After getting some feedback from Chandra, we agree to revise the documents D1900114 and D1900116. This revision is to allocate the air purge valve on the other side of the chamber, now changing the valve from D6 Flange to D2 Flange. The documents are being modified by Don.

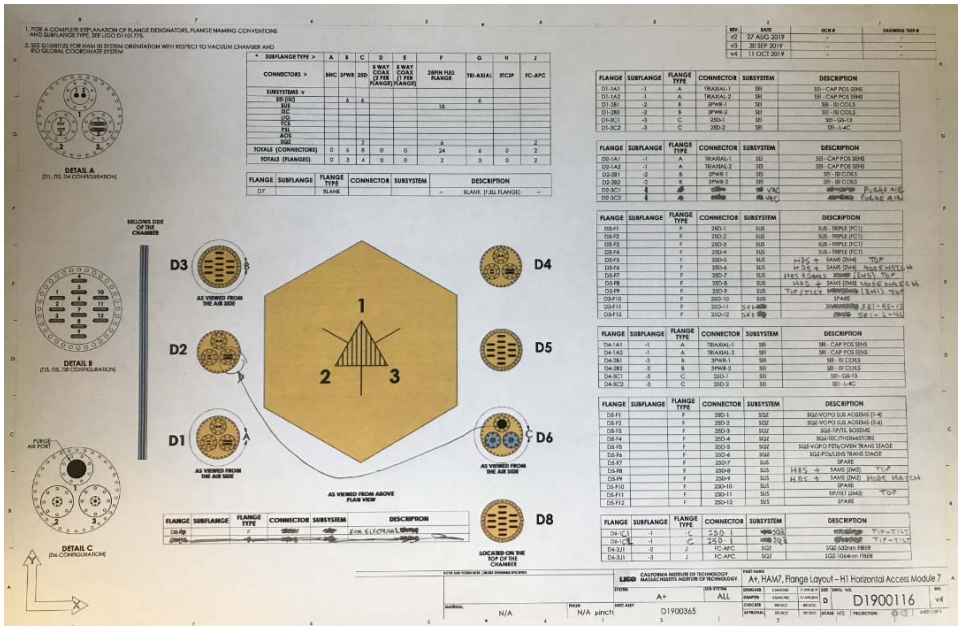
As seen in this image, we are also adding the HDS name for the suspension: HDS + SAMS.

The seismic db25 connectors are being allocated to D3 Flange at D3-F11 and D3-F12. The same modifications are being made to document D1900116.
